APPLICATION NO.	FILING DATE	FIRST NAMED INVENTOR	ATTORNEY DOCKET NO.	CONFIRMATION NO.
10/758,802	01/15/2004	Dae-Woong Kang	8750-042	6500
20575 7590 04/20/2007 MARGER JOHNSON & MCCOLLOM, P.C. 210 SW MORRISON STREET, SUITE 400 PORTLAND, OR 97204			EXAMINER WARREN, MATTHEW E	
			ART UNIT 2815	PAPER NUMBER
			MAIL DATE 04/20/2007	DELIVERY MODE PAPER

Advisory Action Before the Filing of an Appeal Brief	Application No. 10/758,802	Applicant(s) KANG ET AL.	
	Examiner Matthew E. Warren	Art Unit 2815

FIG. 14

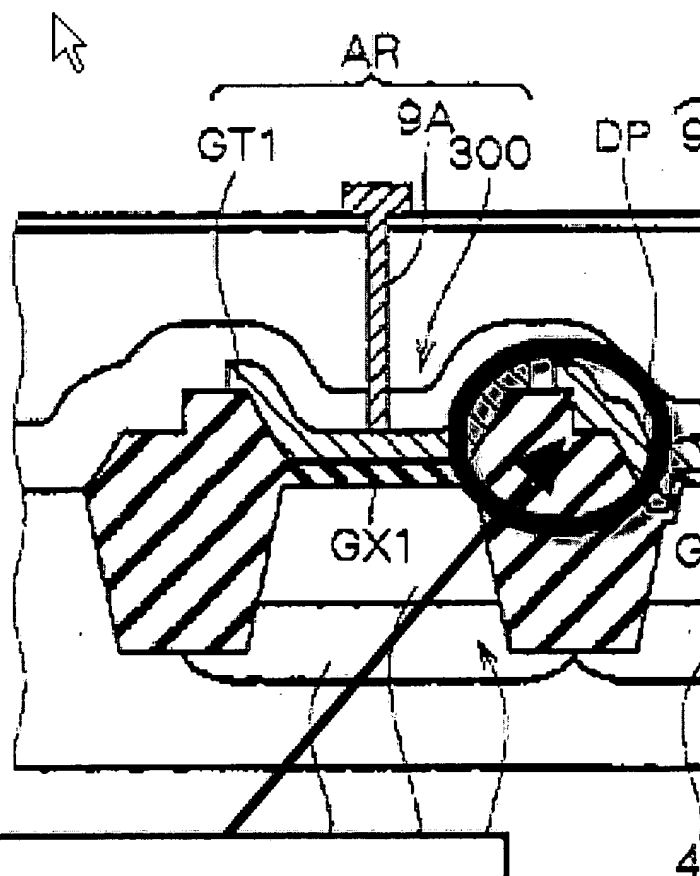
Continuation of 11. does NOT place the application in condition for allowance because: the applicant's arguments are not persuasive. The applicant primarily asserts that Furuta does not show all of the elements of the claims including the limitation of the corner region being spaced laterally away from a vertical axis passing through an upper edge corner of the channel implant region. The examiner still believes that Furuta shows all of the elements of the claims including the limitation in question. The applicant assumes that the corner region in question illustrated in fig. 14 of Furuta is the one that faces the channel implant region. However, as shown in the attached drawing of fig. 14 of Furuta, the corner region interpreted by the examiner faces away from the channel implant region. The corner region of Furuta is definitely spaced laterally away from the vertical axis passing through an upper edge corner of the channel implant region since it is formed above the second, thicker gate oxide layer (GX1) and in the middle of the isolation region (2). This corner region is still part of what the applicant considers "the first-type step regions." The claims do not require that the step region face towards the channel implant region. Therefore, Furuta shows all of the elements of the claims including the limitations in question and the rejection is proper.

Continuation of 13. Other: See the attached drawing Figure 14 (Furuta, US 6,921,947) with the examiner's comments/highlights.

Examiner's interpreted
corner region.
